CITY OF SOMERVILLE, MASSACHUSETTS
MAYOR'S OFFICE OF STRATEGIC PLANNING & COMMUNITY DEVELOPMENT
JOSEPH A. CURTATONE
MAYOR

Your application for a *de minimis* revision to your approved plans at 56 & 61 Clyde Street, case number PB 2008-07-DC1 (4/2013), has been accepted.

The attached elevations approved by the Planning Board on 1/6/2011 have been marked up to identify façade changes made during the construction phase. Elevations A201 and A202 were marked up by Planning Staff during inspection for the issuance of the Building A temporary Certificate of Occupancy. All other elevations have been marked up by ICON Architects.

MAXPAC
SQUARE

SKC-6

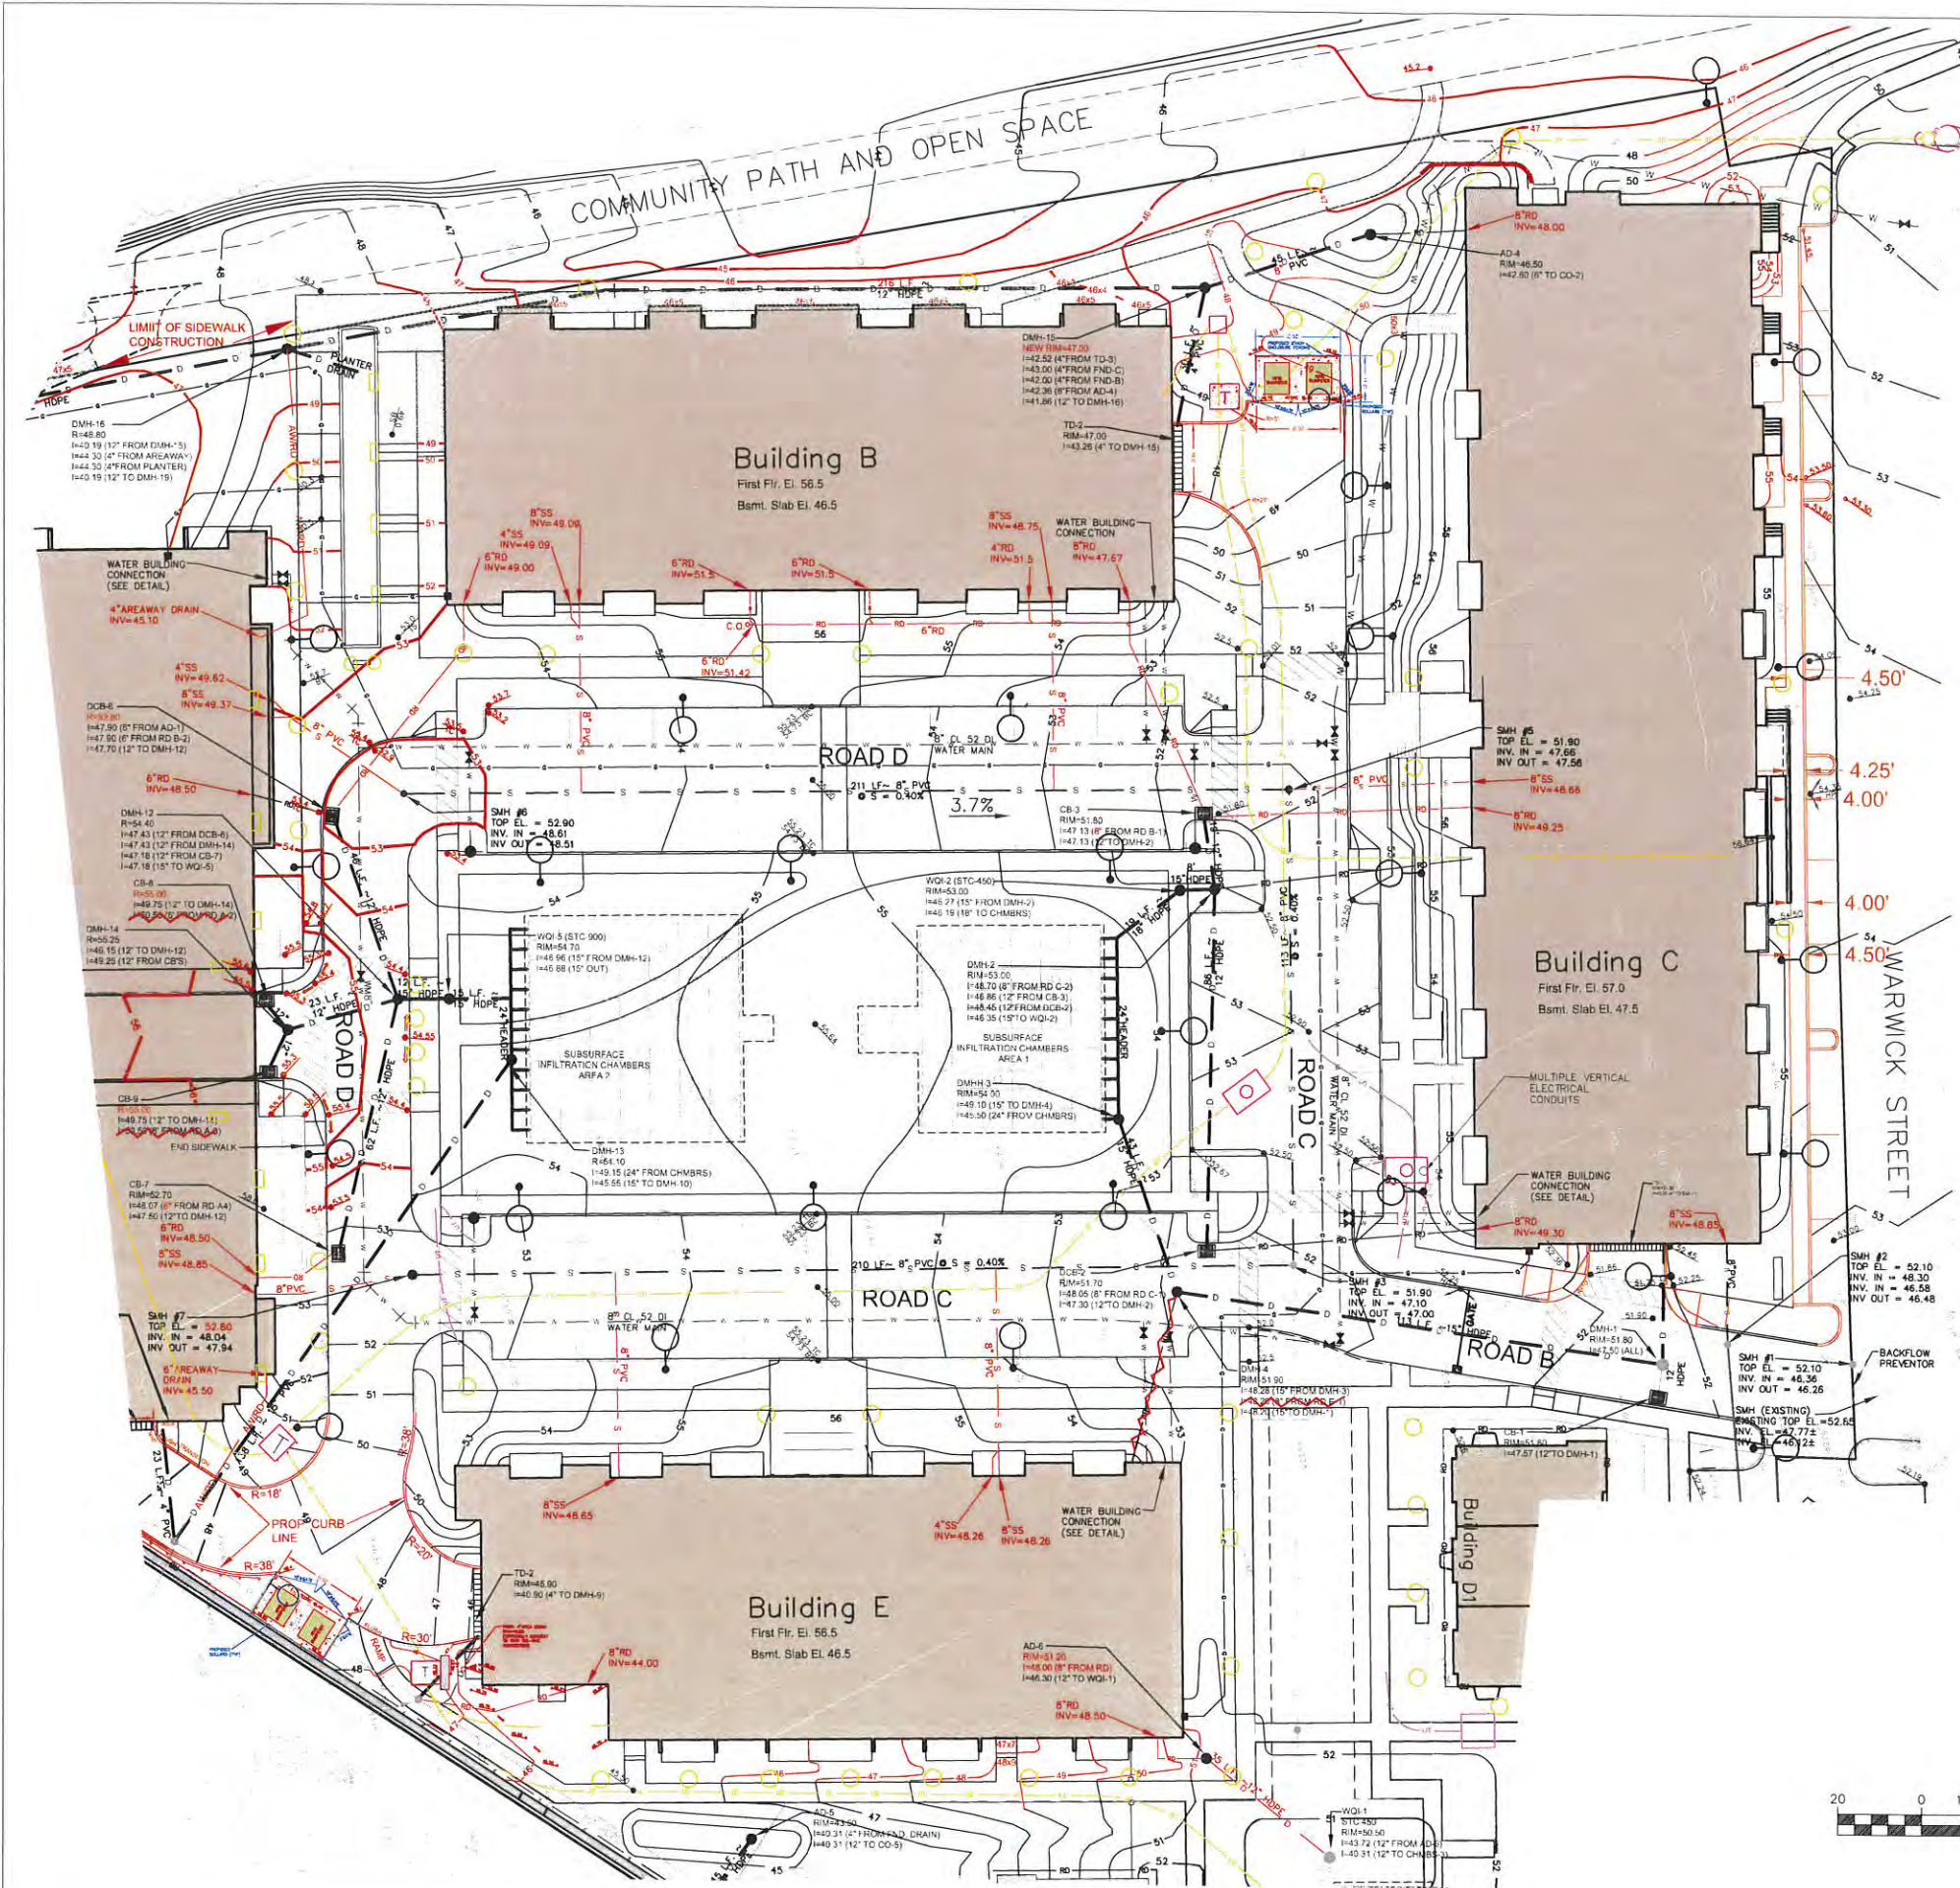
08-7-12	CHANGE CURB RADIUS INTO BLDG E GARAGE TO R=20'
	07-16-12	HP RAMP GRADE ON ROAD E. CURB RADIUS INTO BLDG E GARAGE. INTERSECTION ROAD D&E GRADES
	07-09-12	ROAD E GRADES THRU BLDG A. ADJUST RIM DMH-18 & DCB-6, ROAD D GRADES
	07-05-12	LIGHT LOCATIONS: ADD CURB CUT AND CROSS WALK ON ROAD E
	06-25-12	ADA ACCESSIBILITY GRADES, LIGHTS, DUMPSTERS, GAR. ENTR., COMM PATH WALKWAYS
	04-11-12	ADJUST DRIVEWAY ALIGNMENT AND SIDEWALKS PER 2ND FLR OVERHANG
	11-09-11	LOWELL ST GRADES SIGN
	10-24-11	BLDG A GRADES, GAR. ENTR.
	10-11-11	ELECTRICAL SERVICE
1	MARK	DATE DESCRIPTION

SKC-7

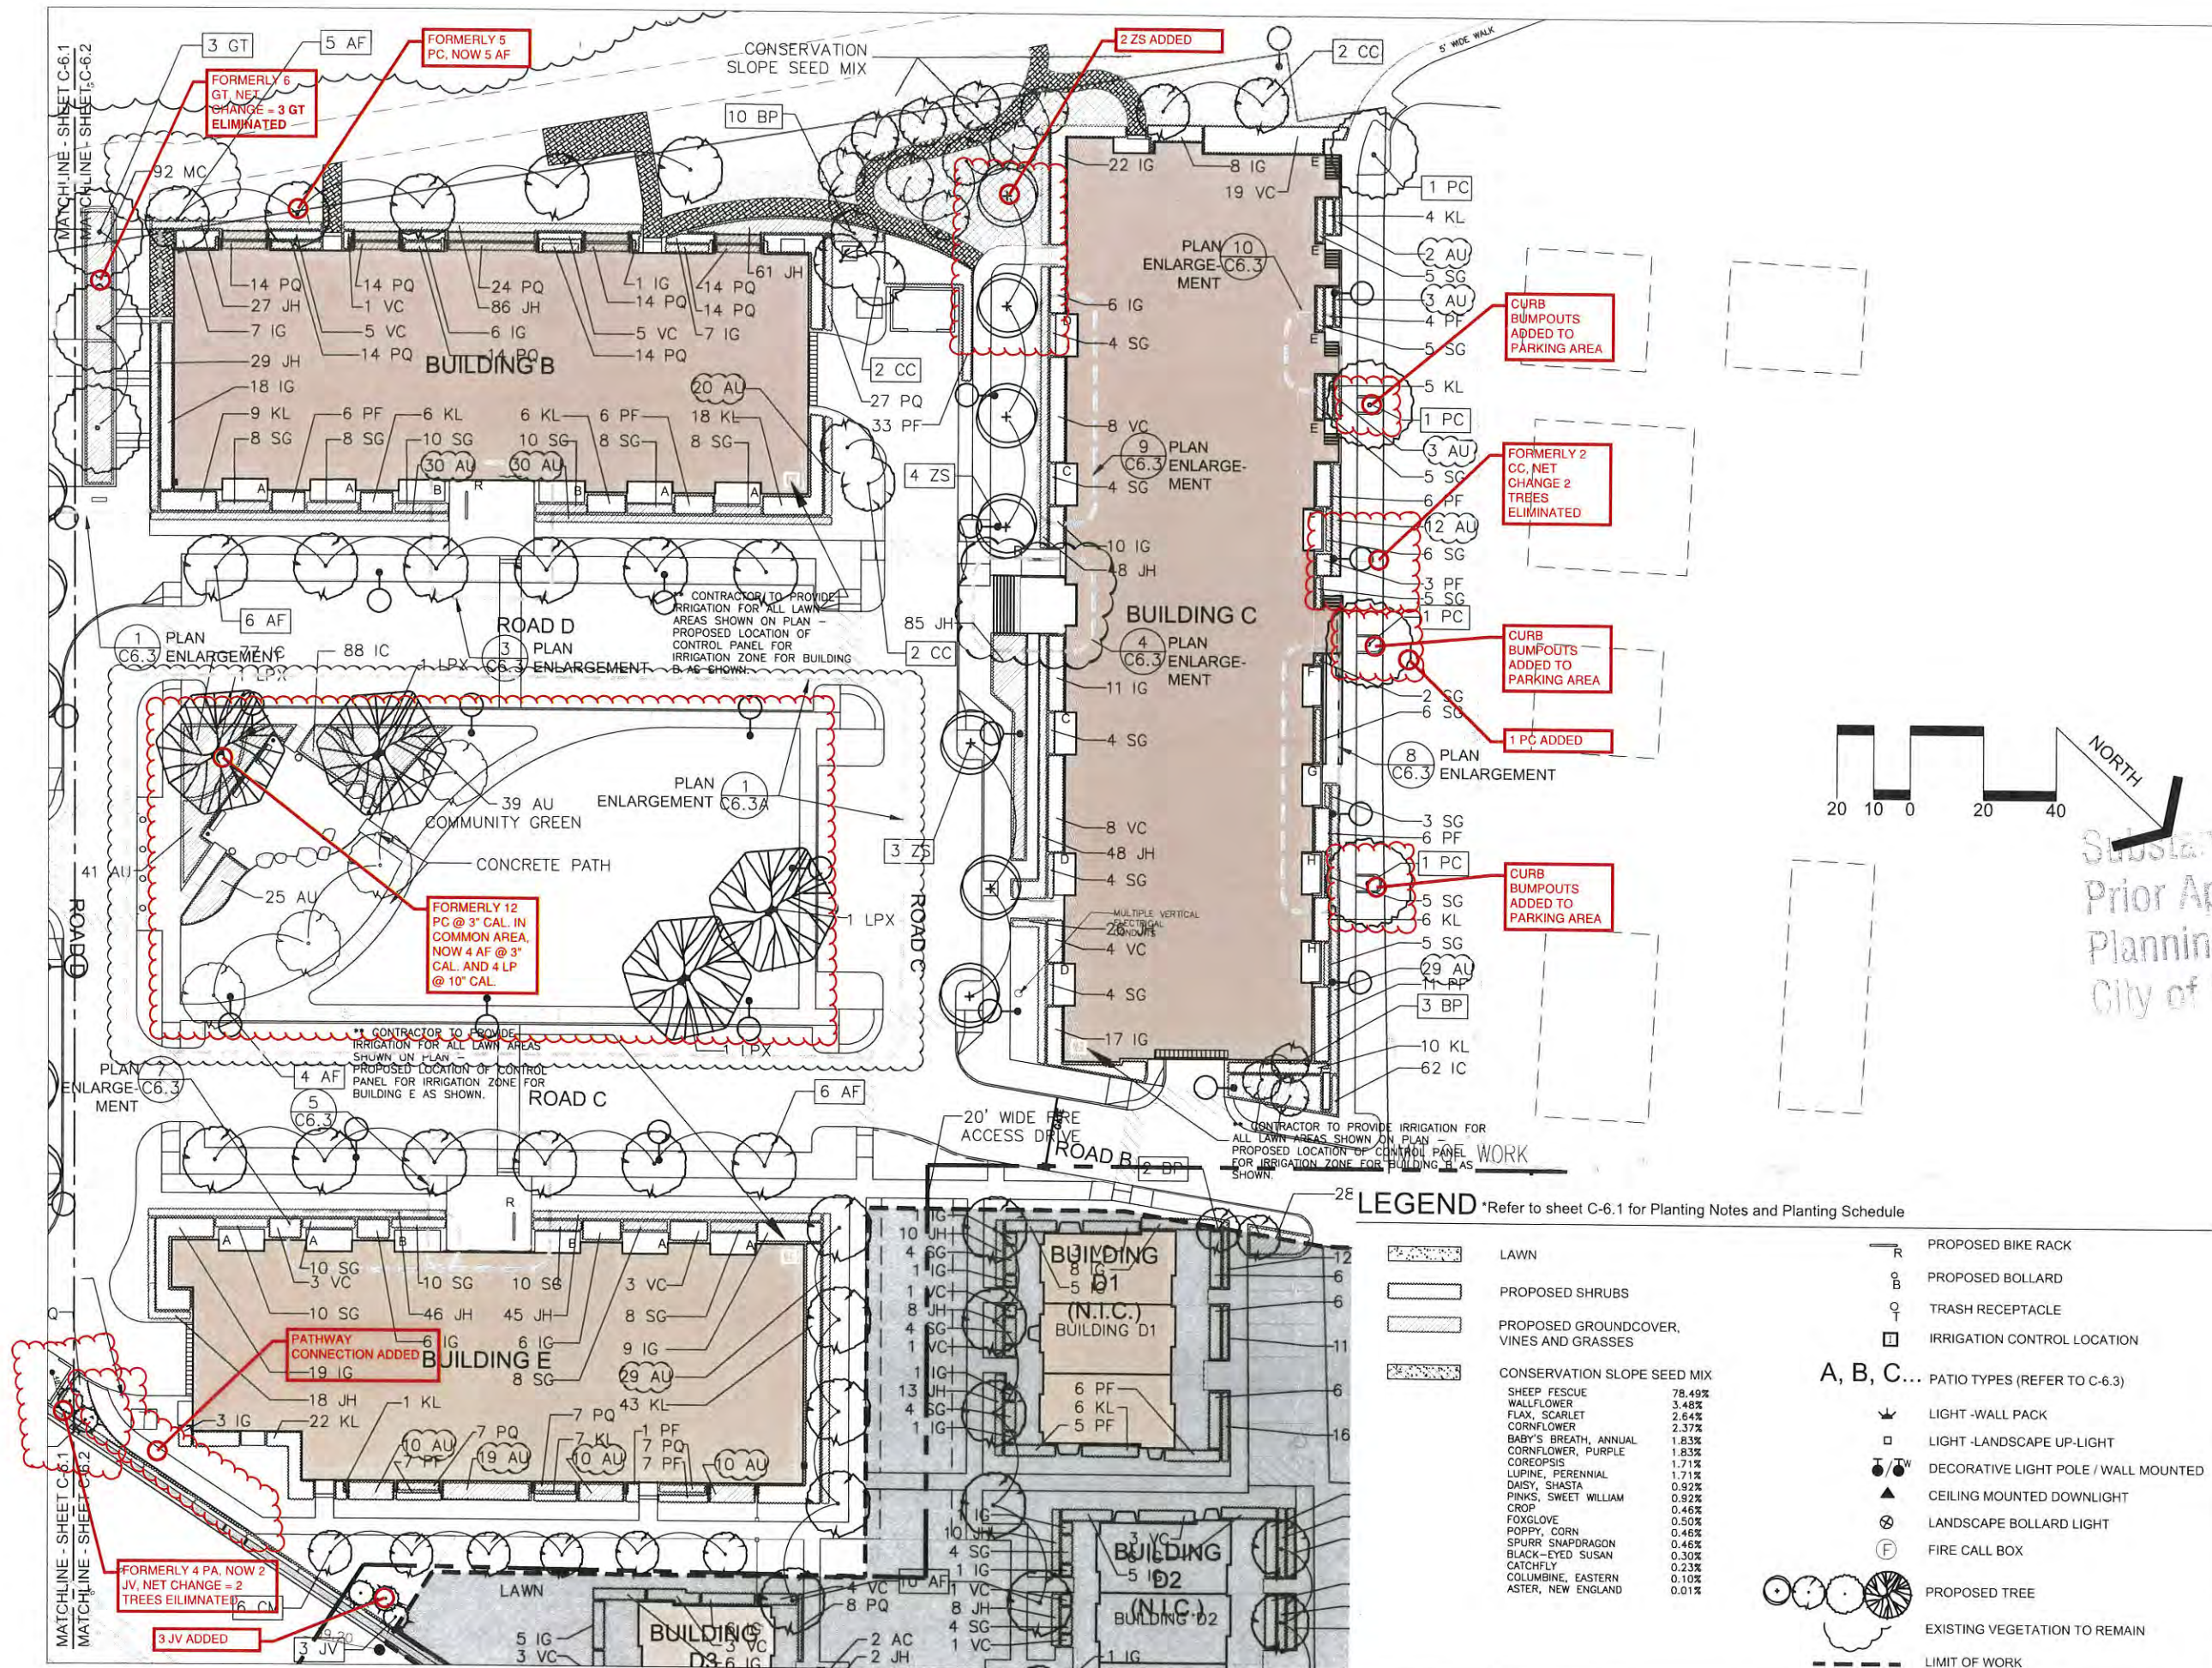
08-7-12	CHANGE CURB RADIUS INTO BLDG E GARAGE TO R=20'
07-16-12	HP RAMP GRADE ON ROAD E, CURB RADIUS INTO BLDG E GARAGE INTERSECTION ROAD D&E GRADES
07-09-12	ROAD E GRADES THRU BLDG A ADJUST RIM DMH-18 & DCB-6, ROAD D GRADES
07-05-12	LIGHT LOCATIONS, ADD CURB CUT AND CROSS WALK ON ROAD E
06-25-12	ADA ACCESSIBILITY GRADES, LIGHTS, DUMPSTERS, GAR. ENT., COMM PATH WALKWAYS
04-11-12	ADJUST DRIVEWAY ALIGNMENT AND SIDEWALKS PER 2ND FLR. OVERHANG
11-09-11	LOWELL ST GRADES SIGN, SITE GRADING UPDATES
10-24-11	BLDG A GRADES, GAR. ENTR.
10-11-11	ELECTRICAL SERVICE
MARK	DATE DESCRIPTION
